**Town of Davidson  
Design Review Board Regular Meeting  
Town Hall and Community Center  
Community Room 120  
251 South Street  
Wednesday, July 17, 2024 at 5:30 PM**

Date: July 17, 2024  
To: Design Review Board  
From: Lindsay Laird, Senior Planner  
Re: Swimming Hole – Approval of Final Details

Date: July 17, 2024  
To: Design Review Board  
From: Lindsay Laird, Senior Planner  
Re: Sadler Square – For approval of building schematic design

Date: July 17, 2024  
To: Design Review Board  
From: Lindsay Laird, Senior Planner  
Re: 201 South Street – For approval of building schematic design

# EXTERIOR ELEVATIONS

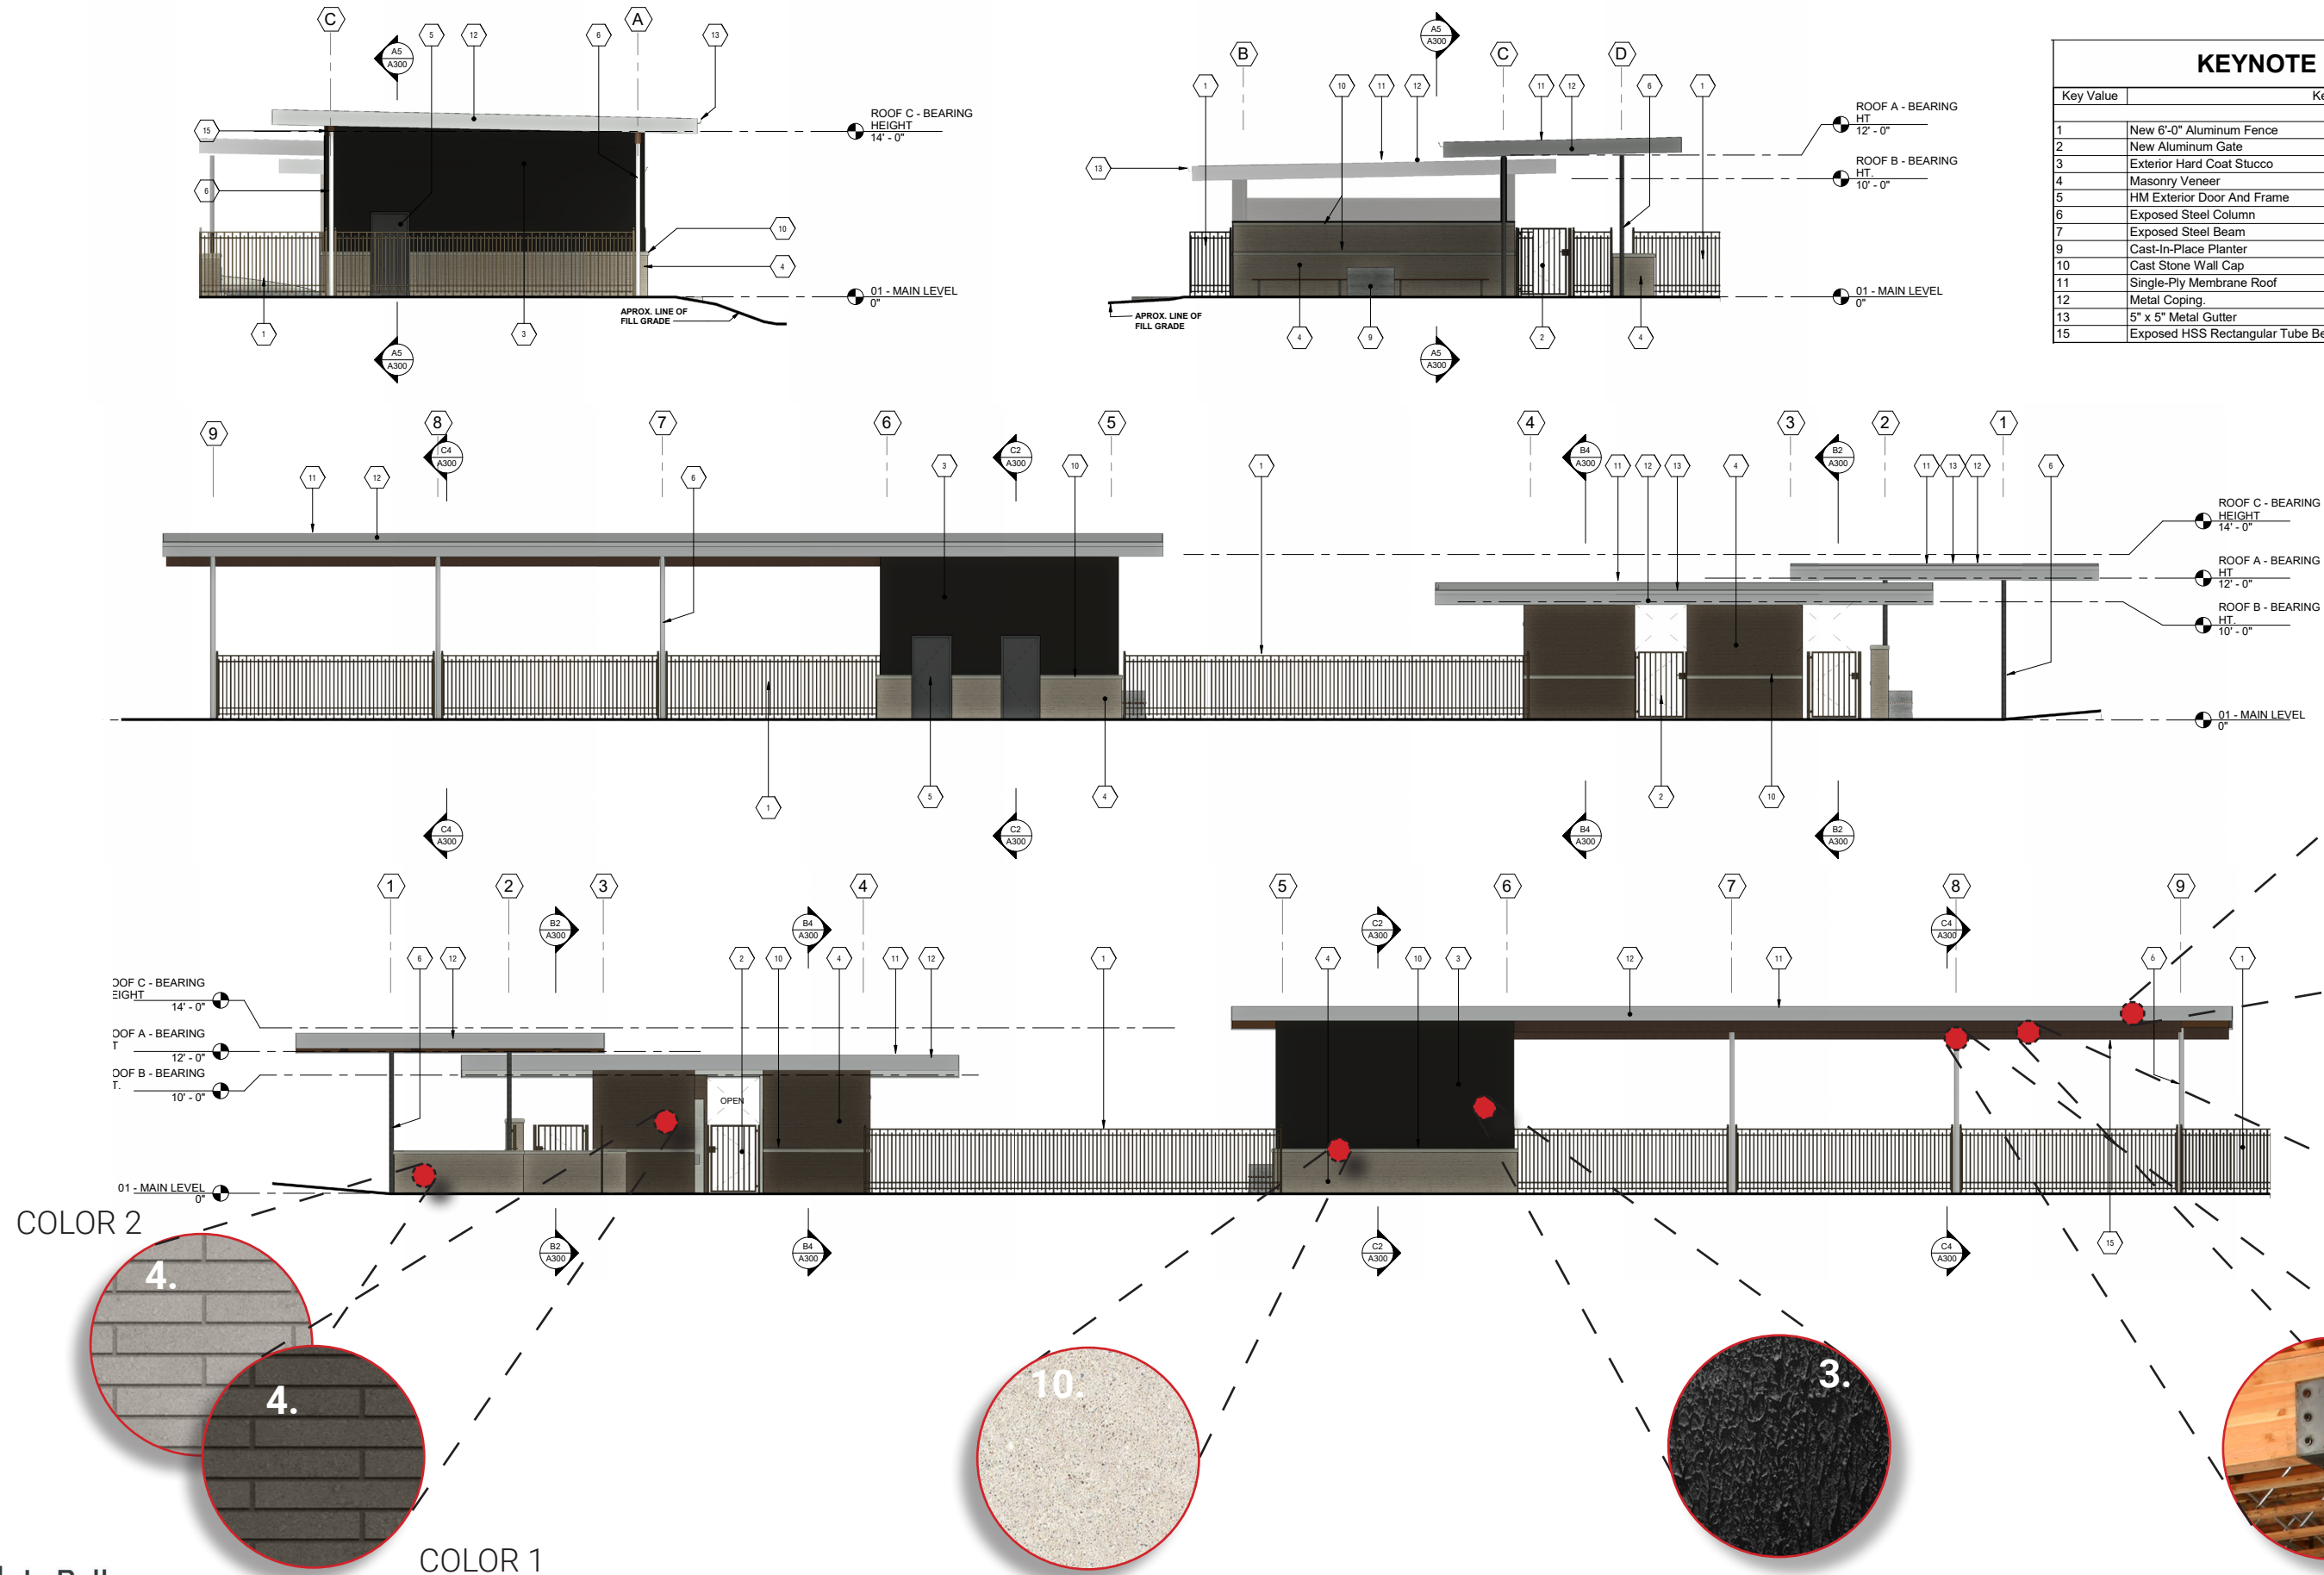
Updated plans include dimensions, revised materials (see Exterior Elevations on sheet 10), roof detailing (see Roof Plan A3 on sheet 9), and gutters/downspouts (see Building Cross Section A5 on sheet 12).

- **4.4.1.A Building Height:** Compliant
- **4.4.1.B Form and Massing:** Compliant
- **4.4.1.C Façade Articulation:** Compliant – The base of the pool house building is emphasized with a stone water table. The top of the building is emphasized with a roof overhang.
- **4.4.1.D Façade Transparency:** Not applicable
- **4.4.1.E Materials:** Materials shall be selected for suitability to the type of building and design for which they are used. All facades visible from a public street/open space shall utilize high-quality finish materials including, but not limited to: (a) Brick, masonry, or stone; (b) Integrally tinted, textured masonry block; (c) Stucco; (d) Wood or cementitious siding; (e) Glass.  
*Review final material selections for elevations and roofing.*
- **4.4.1.F Architectural Details:** Compliant

PROPOSED ELEVATIONS - RJA PROJECT #2362 - 06.26.2024

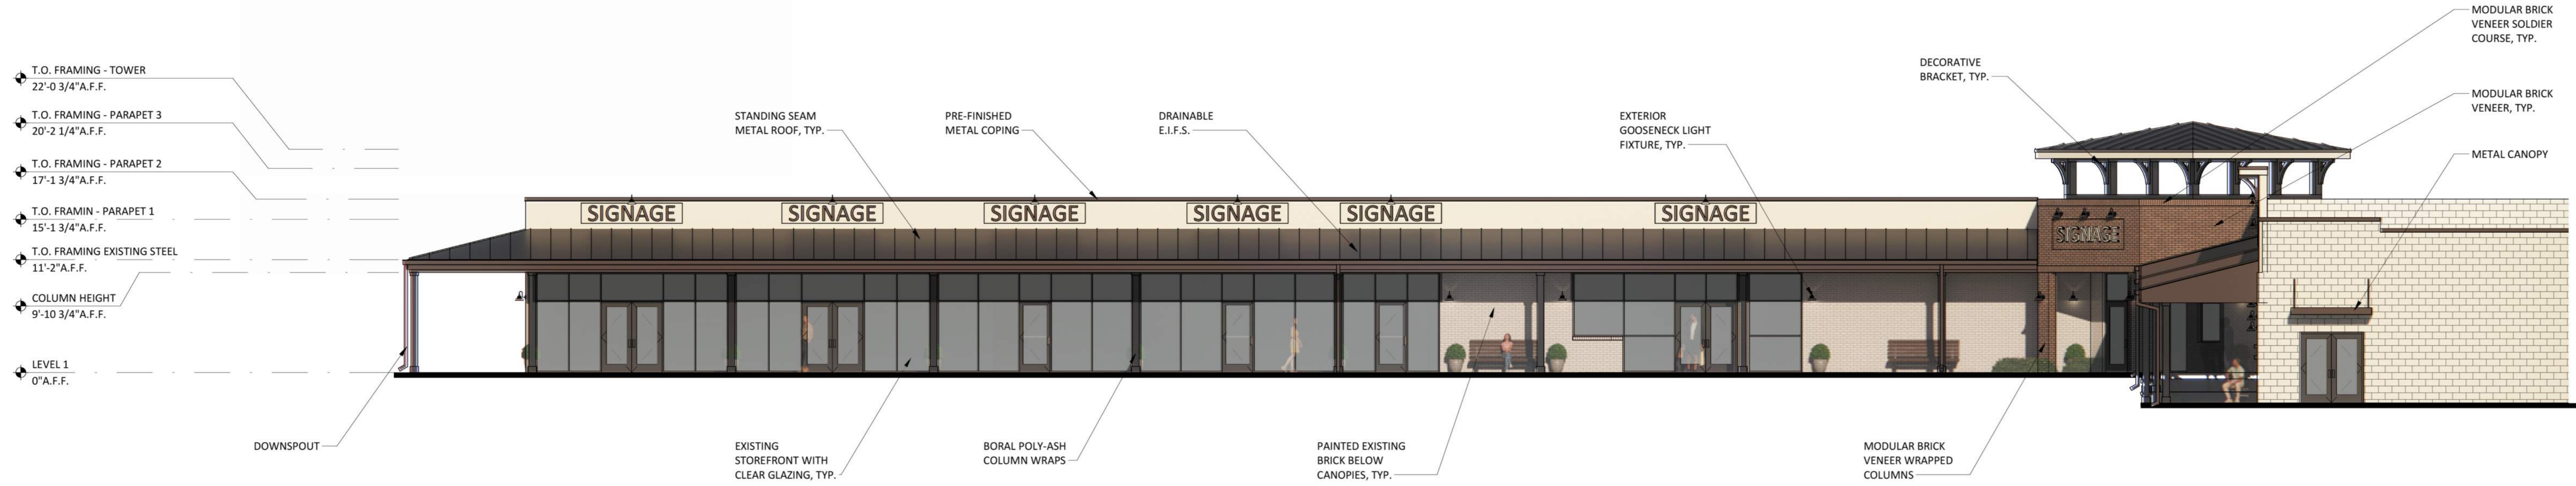
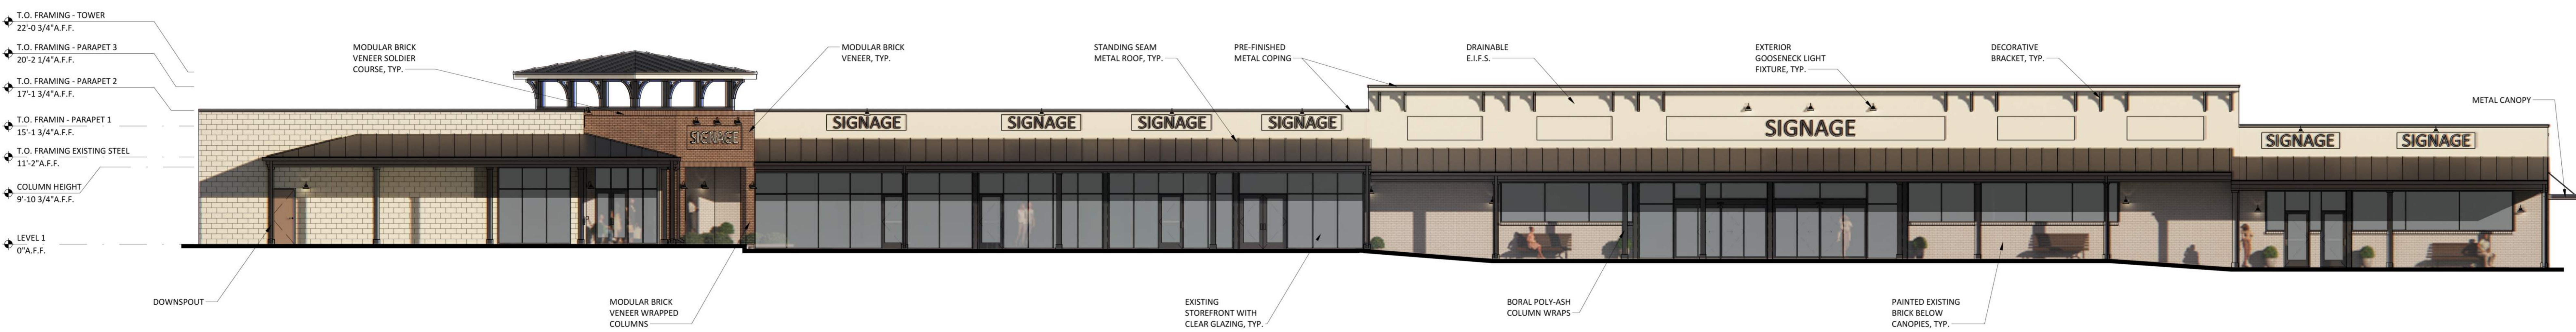
- **4.4.1.A Building Height:** N/A – no changes to building height
- **4.4.1.B Form and Massing:** For large scale buildings, the front façade shall create repetitive bays, or the façade shall be divided into an asymmetrical, yet balanced, composition. Additionally, Buildings on a corner or axial termini should be designed with additional height or architectural embellishments to emphasize their location.  
*Do façade elements (i.e., canopies, parapets, brackets, etc.) create repetitive bays or divide the façade into an asymmetrical yet balanced composition?*

- **4.4.1.F Architectural Details:** Architectural elements like openings, sills, bulkheads, columns, and other architectural features shall be used to establish human scale at the street level.  
*Review canopies/columns and the corner element at the existing entrance to Our Town Cinemas. Do these elements help to establish human scale?*

- **4.5.6.B Façade Transparency:** Compliant – existing building
- **4.5.6.C First Floor Height:** N/A
- **4.5.6.D Proportions:** Building elements shall have a dominant vertical proportion.  
*Do façade changes create verticality to the extent possible on this existing building?*

- **4.5.6.E Active Uses Required:** Compliant – existing building
- **4.5.6.F Multiple Entrances Required:** Compliant
- **4.5.6.G Distinguish Major Entrances:** Major building entrances that provide access to the primary use of the building shall be distinguished from the entrances used for secondary uses.  
*Are entrances to primary uses (i.e., corner tenant (Our Town Cinemas) & anchor (market) tenant) adequately distinguished from entrances to secondary uses?*

# NORTH & SOUTH ELEVATIONS

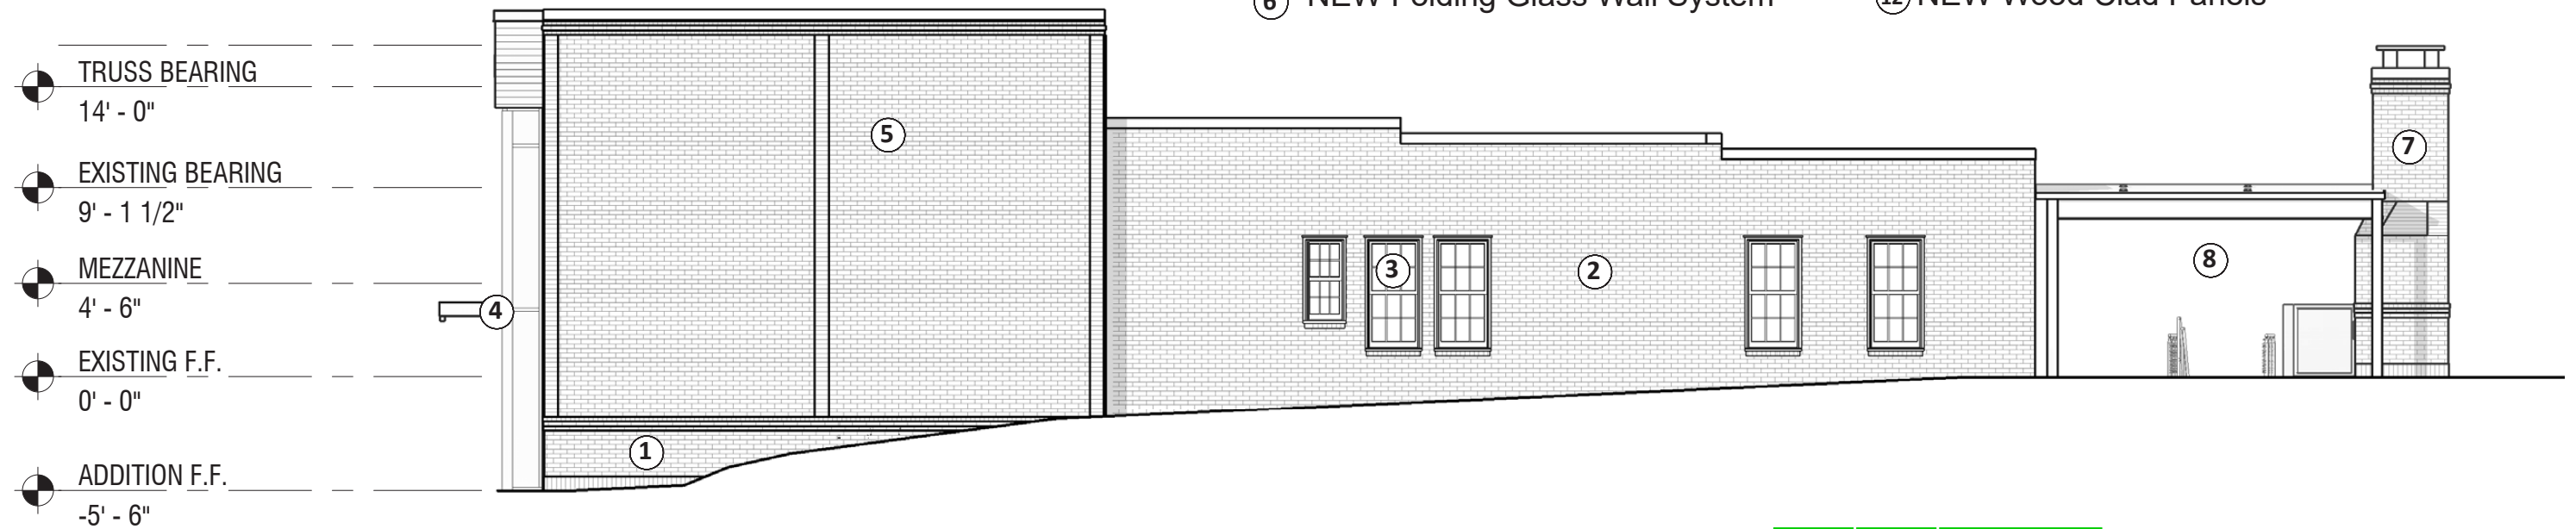
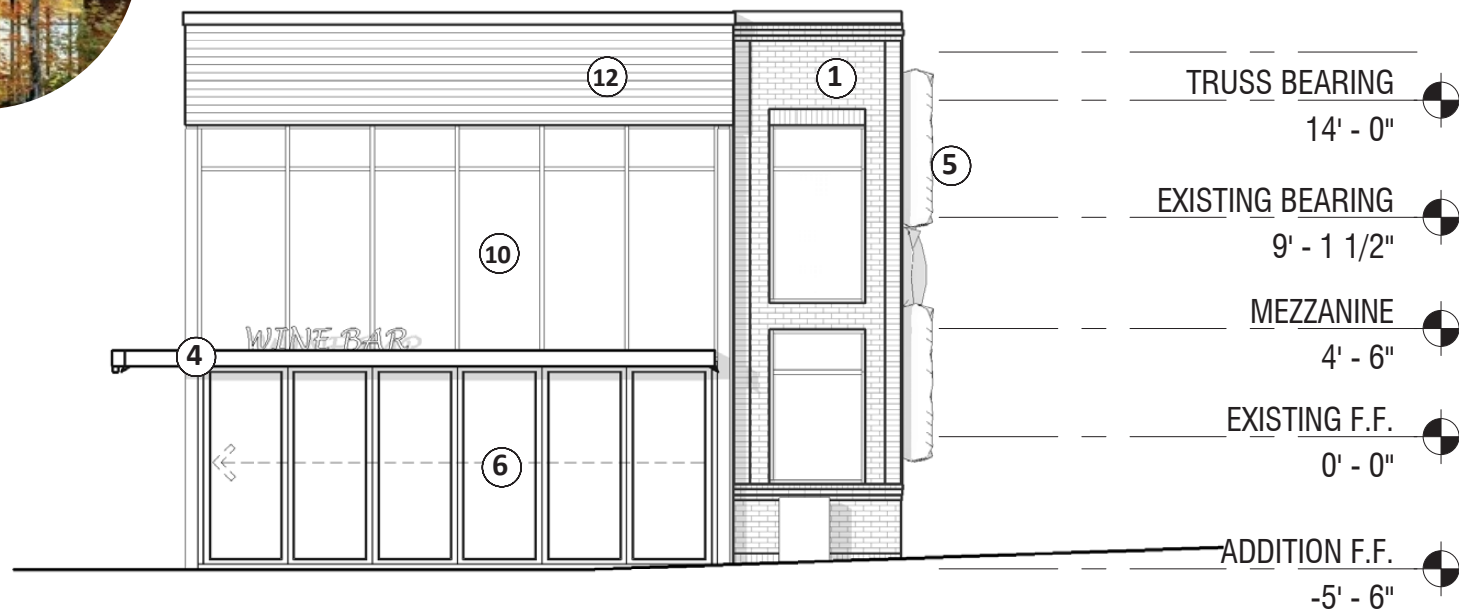
- **4.3.2.I Density:** Compliant - Density should increase closer to mixed use and commercial nodes.
  - **4.3.2.J Building Design:** Buildings should be designed to respect the existing built environment, but not be explicit reproduction of past historical styles.  
*Do the proposed changes respect the existing built environment?*

- D. **4.4 General Building Design Standards**
- **4.4.1.A Building Height:** Compliant (see also 4.7 Renovation of Existing Structures)
  - **4.4.1.B Form and Massing:** Buildings on a corner or axial termini should be designed with additional height or architectural embellishments to emphasize their location.  
*Do the proposed changes adequately emphasize the location of the building at the corner of South Street/S Main Street?*

- **4.4.1.D Façade Transparency:** Compliant – glazing calculation provided on sheet 11
  - **4.4.1.E Materials:** Building materials and colors shall be: (a) Complementary to the materials already being used in the neighborhood, or (b) if dissimilar materials are proposed, other characteristics such as scale, proportion, form, architectural detailing, color, and texture shall be used to ensure that the building relates to the rest of the neighborhood.  
*Are proposed building materials complementary to the materials already in use in the neighborhood?*

- **4.4.1.F Architectural Details:** Architectural elements shall be used to establish human scale at the street level. Fenestration shall be architecturally related to the style, materials, colors, and details of the building. The main entry to a building should be emphasized at the street level.  
*Do architectural elements help to establish human scale at the street level?*

*Is fenestration architecturally related to the style, materials, colors, and details of the building?*

*Is the main entry emphasized at the street level?*
